PRODUCT CHANGE NOTIFICATION

Reference: **EP_1491514**

CA090D-C4N-B

Contactor 90A, 3PDT, 115Vac, 4 Aux PDT, 28Vdc

DESCRIPTION OF THE EVOLUTION

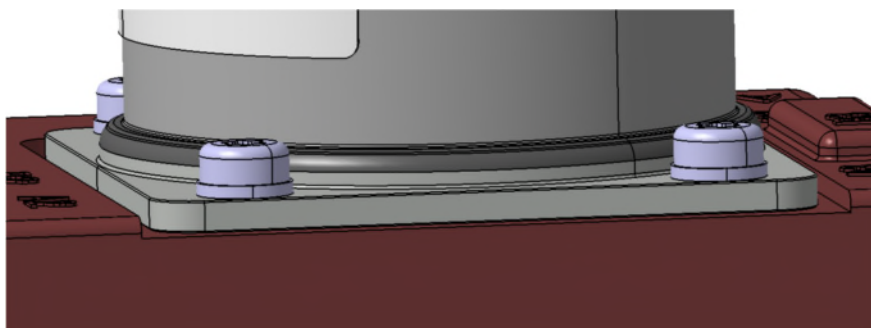
The modification consists of adding a bead of varnish (grey zone) all around the contact area of the motor crimp.

Avoids the risk of corrosion due to the crimping operation and standardization of the operations with the other AC contactors type.

This type of varnish is already used on the component and has been qualified (bead around the motor) on another AC contactor.
